Location Address: 901 S. Federal Hwy., Hollywood FL 33020

TECHNICAL ADVISORY COMMITTEE REPORT

FILE NUMBER: 19-DP-35

SUBJECT: Site Plan review for a 100 unit residential development. (Fiori Village).

SITE GROUND FLOOR PLAN

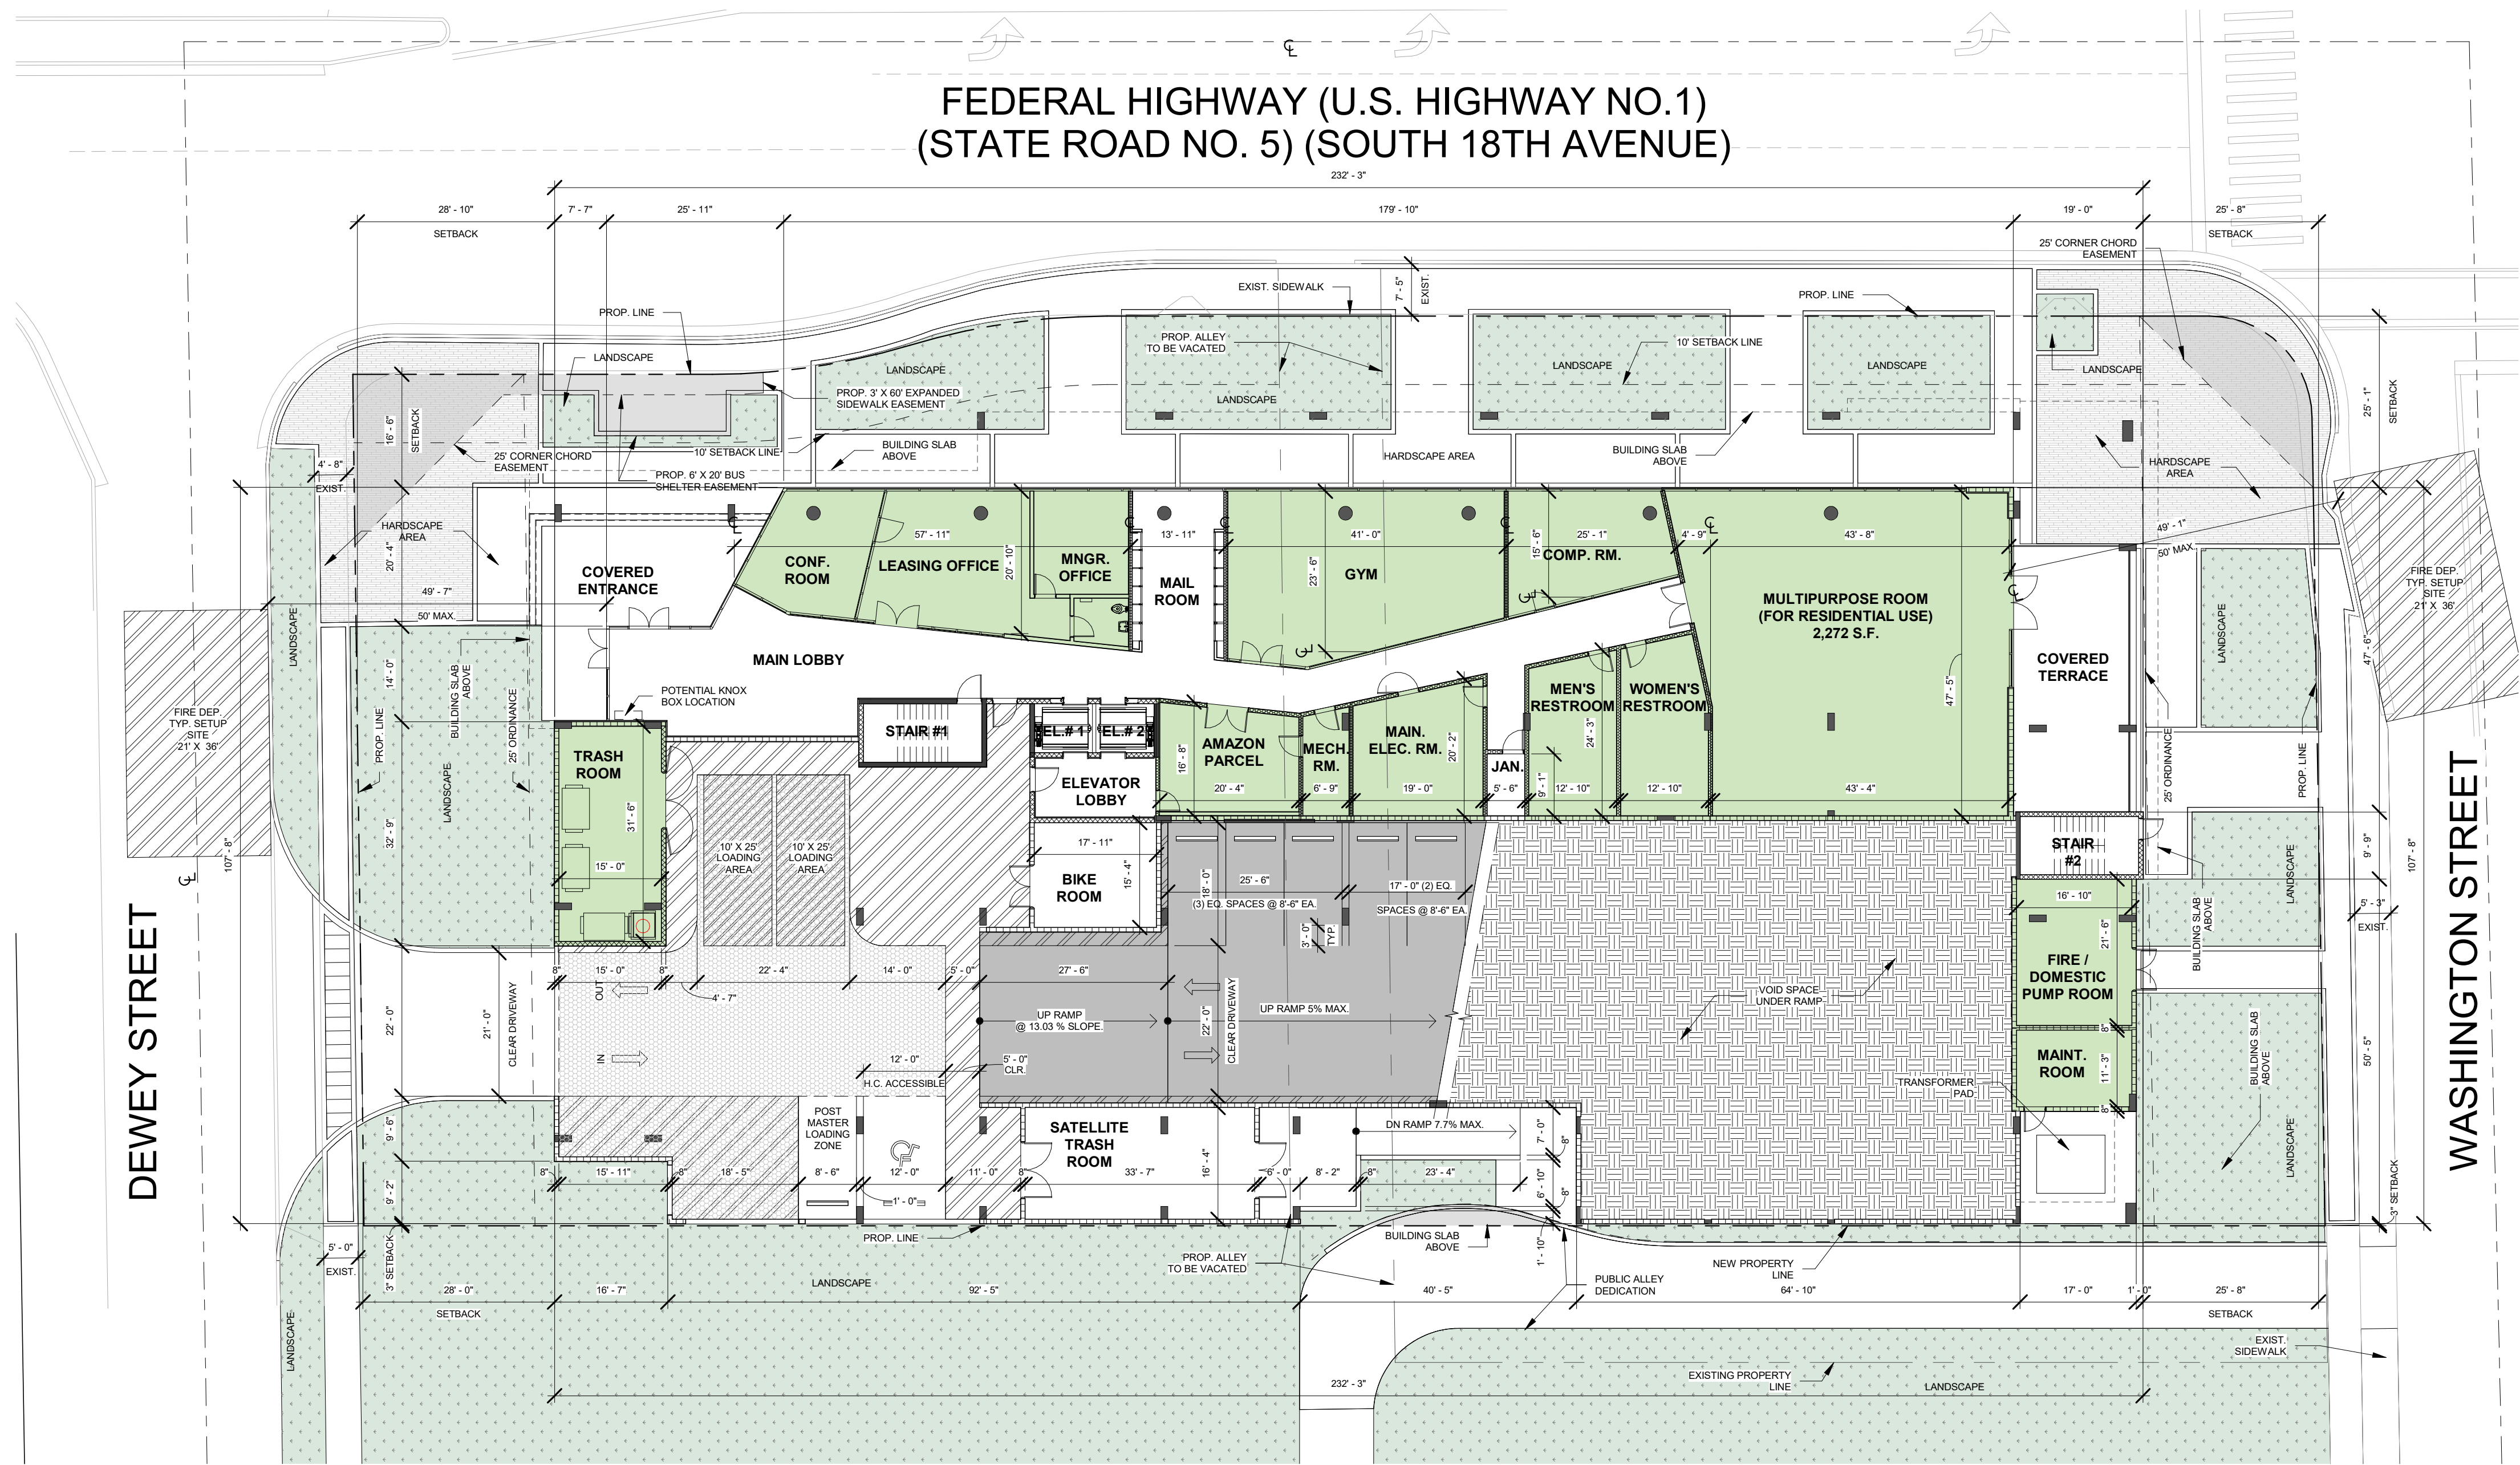
- a. Property Line does not match survey. Revise accordingly. Ensure that property line is clear on site plan. (line weight and line type)

- b. Site plan shall be fully dimensioned, including building lengths and proposed setbacks.

- a. Future land Use Designation incorrect. Revise accordingly

- b. Note height of base and tower requirements.

- c. Include existing and proposed lot area.

- d. Provide floor area of each type of unit, including a breakdown of air-conditioned and non-air-conditioned space (balconies garages, terraces, etc)

- e. Provide average unit size.

- f. Provide a breakdown of the common areas (restrooms, power equipment rooms, and meter rooms)

See revised Site Plan, Sheet A-1.00

See revised Site Plan, Sheet A-1.00

Land use has been changed, refer to sheet A-1.00

See revised Site data, Sheet A-1.00

See revised Site Data, Sheet A-1.00

See Unit Areas Breakdown Schedule at sheet A-1.00

See average unit size at sheet A-1.00

See schedule at sheet A-1.00

A-2.01

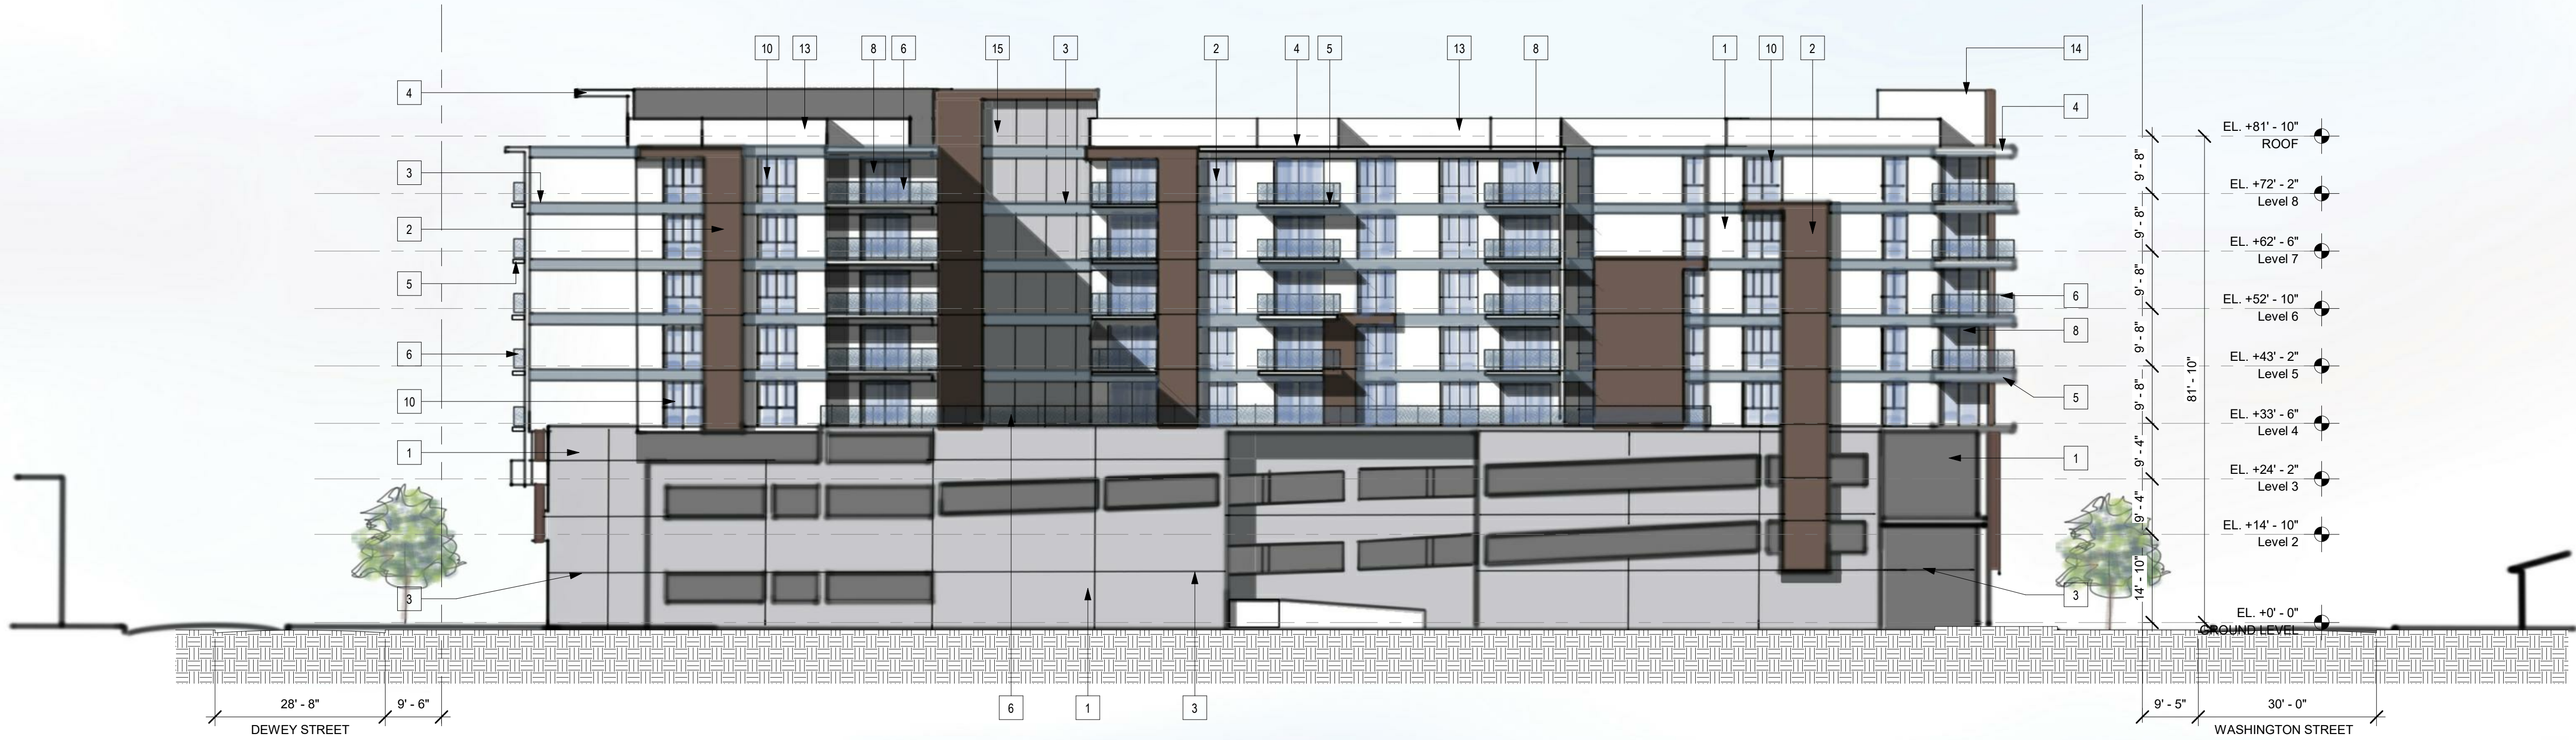
- 8 Indicate and provide minimum 14' vertical clearance at the garage entrance for the loading spaces and van accessible ADA parking, please show on Sheet A-2.01.
Refer to sheet A-1.00 legend and sheet A-2.01 for dimension
